Validation Report

**VALIDATION OF THE CDM-PROJECT:
GUIZHOU QINGSHUIHE GELIBRIDGE HYDROPOWER
PROJECT**

REPORT NO. 600500250

2010, September 29

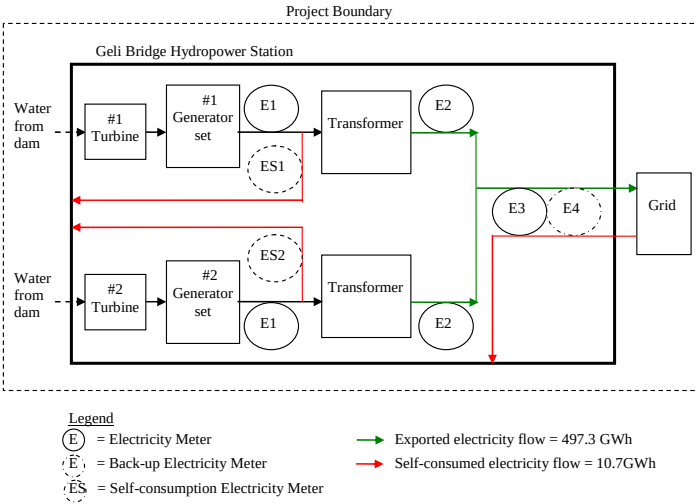
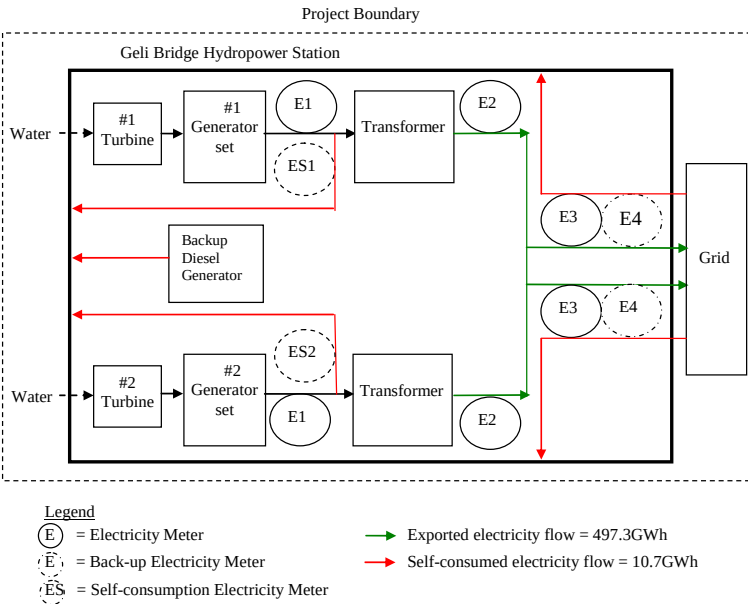
Corrective Action Request No.3. According to the latest PDD guidelines, this section should include a detailed description of: (a) The scenario existing prior to the start of the implementation of the project activity, with a list of the equipment(s) and systems in operation at that time; and (c) The baseline scenario, as identified in section "B.4 Description of how the baseline scenario is identified and description of the identified baseline scenario", with an indicative list of the equipment(s) and systems that would have been in	A.4.3.2	Section A.4.3 in PDD version 5 has been revised to include the scenario existing prior to the start of the implementation of the project activity as follows: The scenario existing prior to the implementation of the project activity is the same as the baseline scenario, where delivery of electricity to the grid by the operation of grid-connected power plants and, in the absence of implementation of the project activity, by the addition of new generation sources. The equipment and systems in operation prior to the start of the project activity are the power plants (mostly thermal, and mostly coal) supplying electricity to the South China Grid and set out in Annex 3. These in-	☒ The section of the PDD has been revised accordingly and is now in line with the latest PDD guidelines (Version 07) available at the time of validation.

Clarifications and corrective action requests by validation team	Ref. to table 1	Summary of project owner response	Validation team conclusion
		backup power, and describes the emission sources involved in both the project activity and the baseline. Figure B.3-1 (as shown below) has been revised.  Third response (wrt follow-up 2): Figure B.3-1 has been revised to the following:	In addition, figure B.3-1 is still missing the emissions sources and gases included in the project boundary. Please add these sources accordingly. Follow-up 2: The figure is still missing the emission sources and gases that are included in the project boundary as indicated in the PDD guidelines. Please add the relevant sources. Conclusion: The revised figure is complete and also indicates the emission sources.
